# Corridor 11-103

## Prineville Corridor

### Corridor Purpose and Rationale

Figure 4. Corridor 11-103, Corridor Density Map

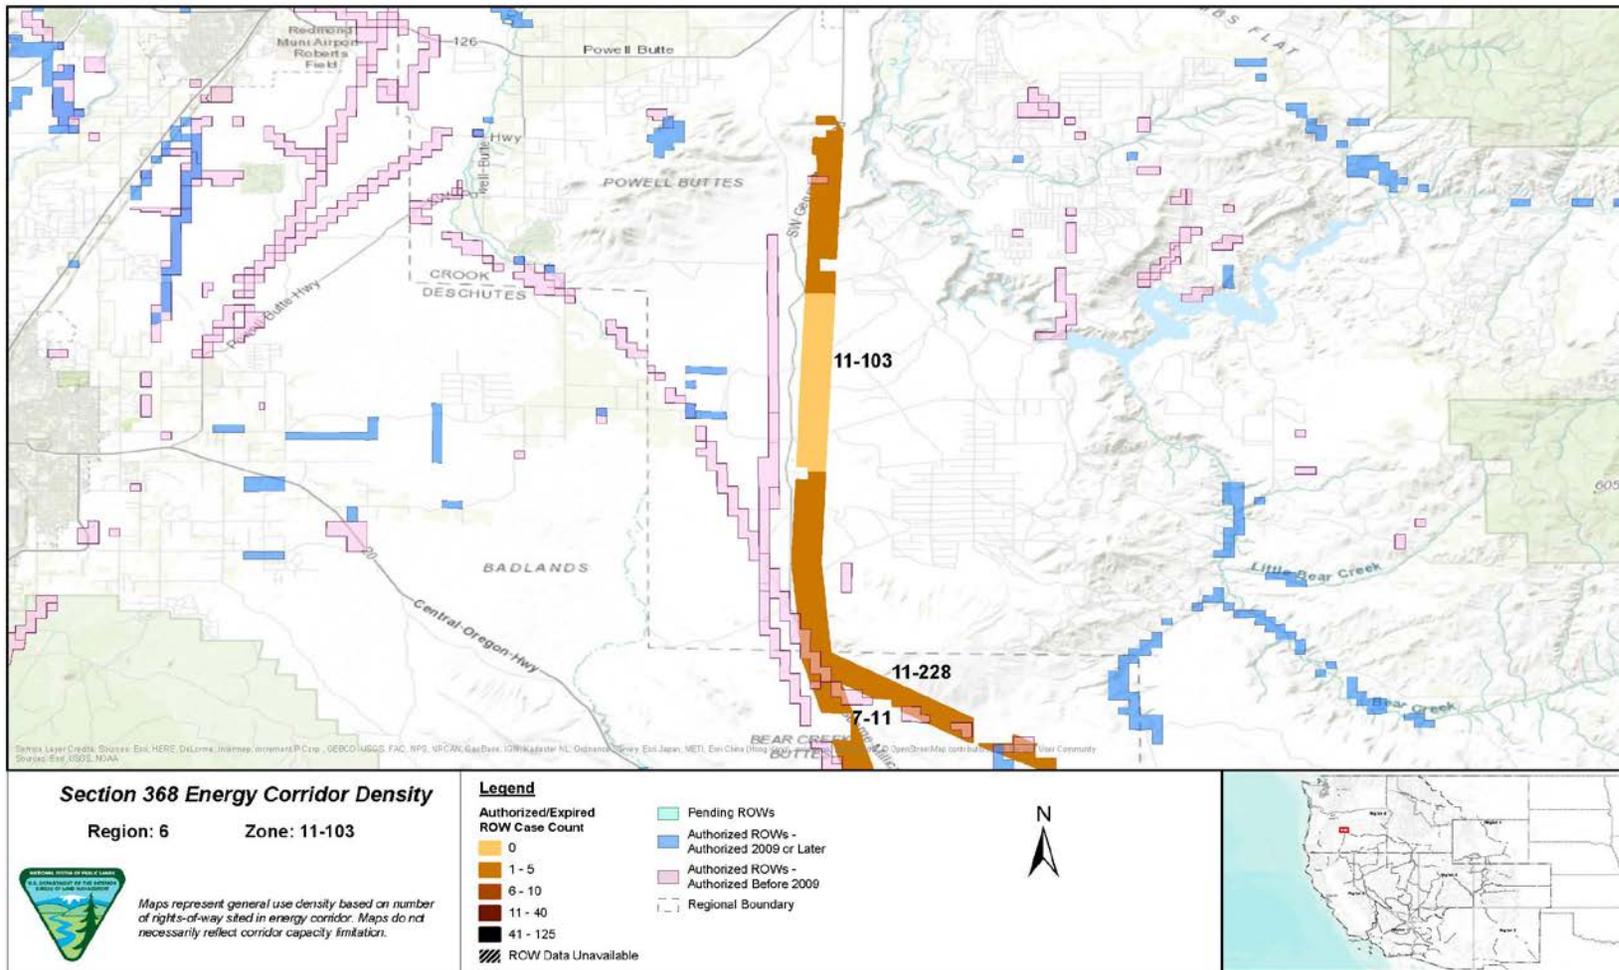
Figure 4 shows the density of energy use to assist in evaluating corridor utility. ROWs granted prior to the corridor designation (2009) are shown in pink; ROWs granted after corridor designation are shown in blue; and pending ROWs under current review for approval are shown in turquoise. Note the ROW density shown for the corridor is only a snapshot that does not fully illustrate remaining corridor capacity. Not all ROWs have GIS data at the time this abstract was developed. BLM and USFS are currently improving their ROW GIS databases and anticipate more complete data in the near future.
